Clause 83E Module Stressed input signal generation (Comment i-101)

Mike Dudek QLogic

7/13/2014

With slower Gaussian filtered risetime (20ps) draft 3.0 channel

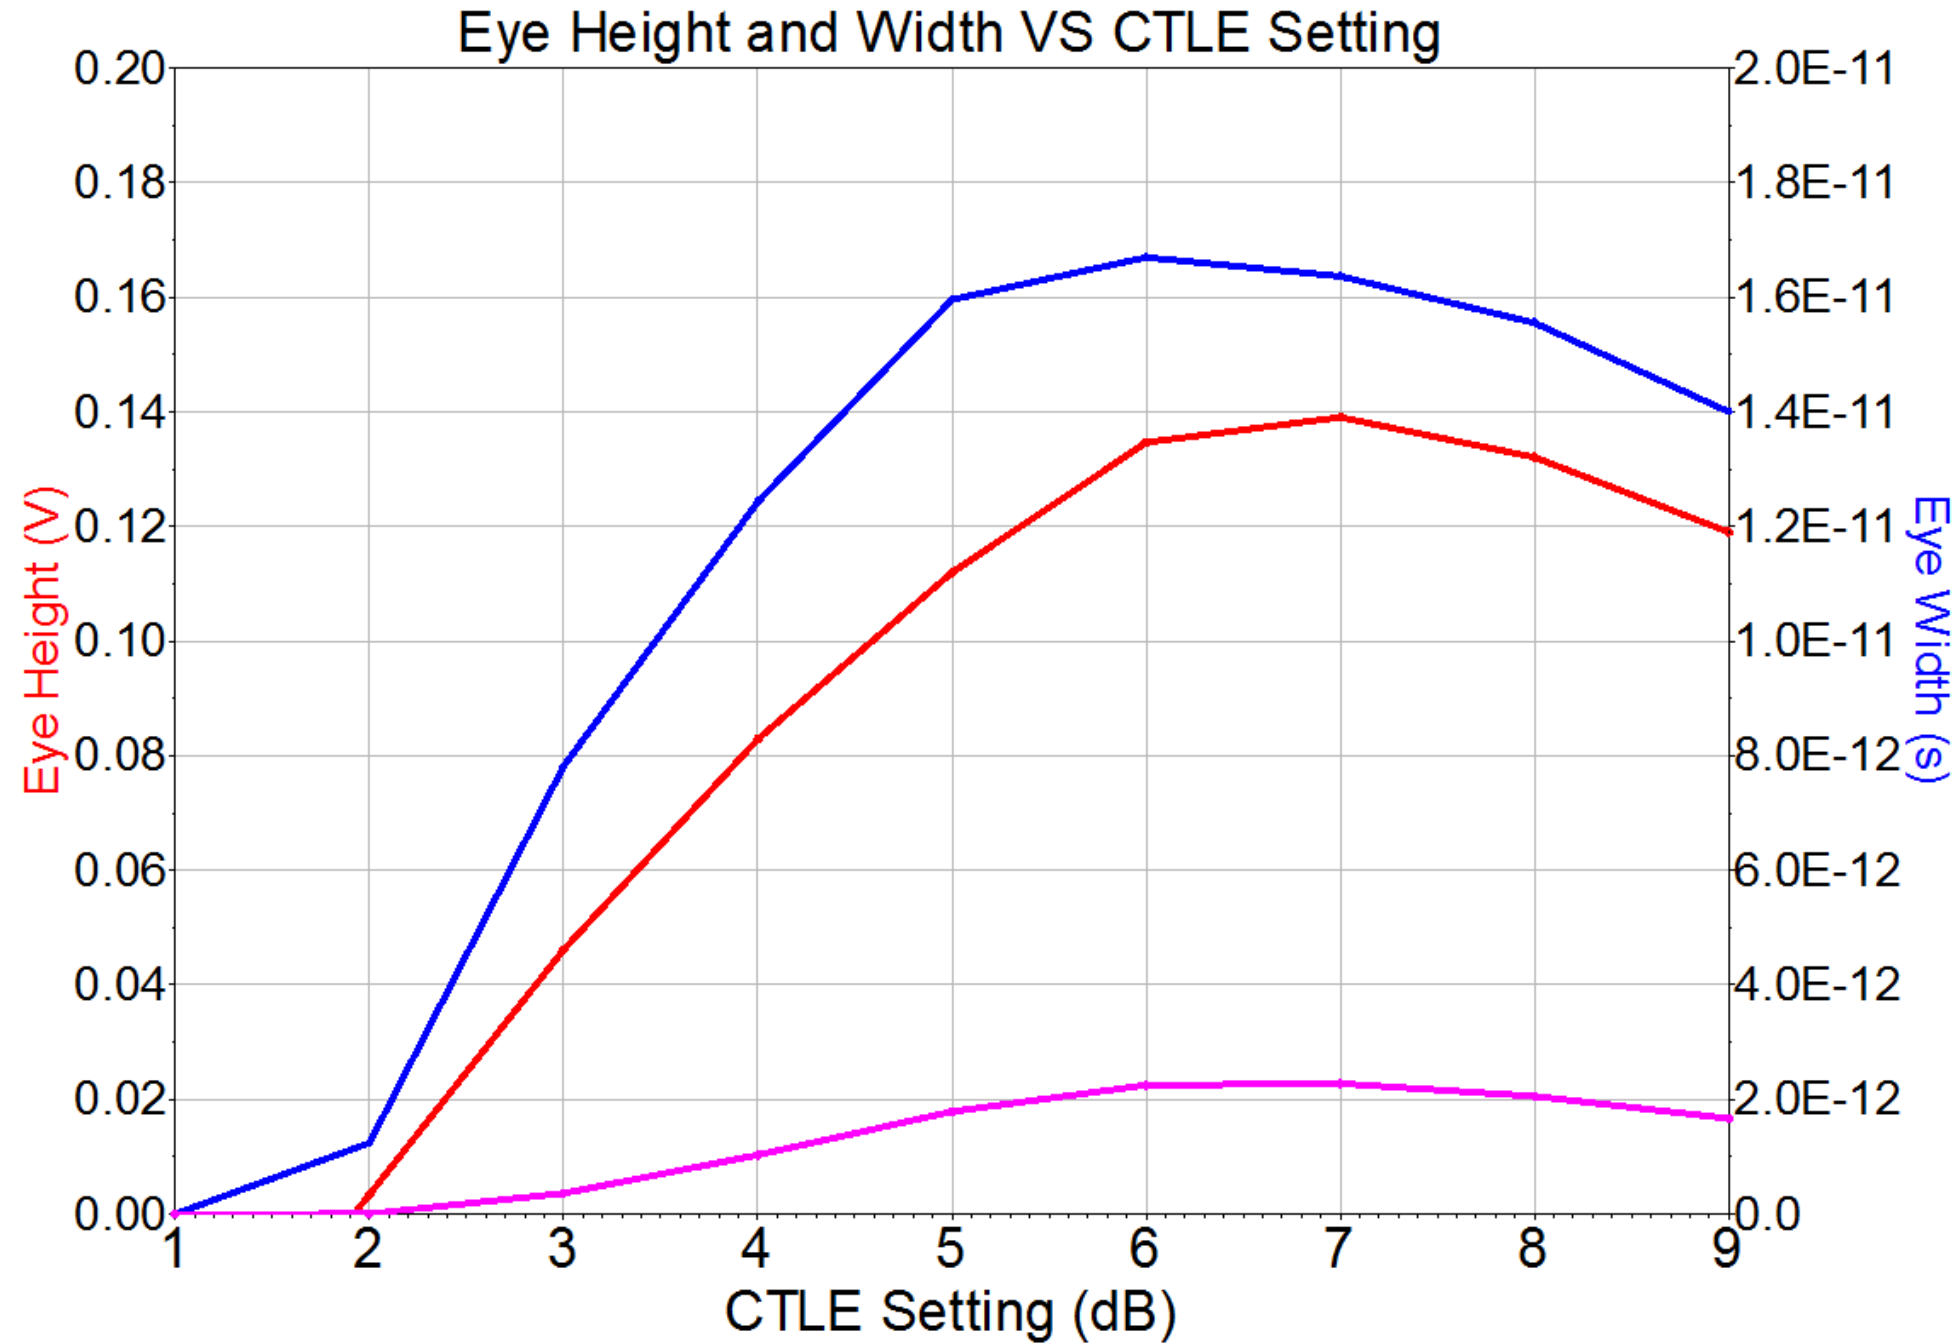
**Optimum only 7dB.
Eye width too narrow
with zero Rj**
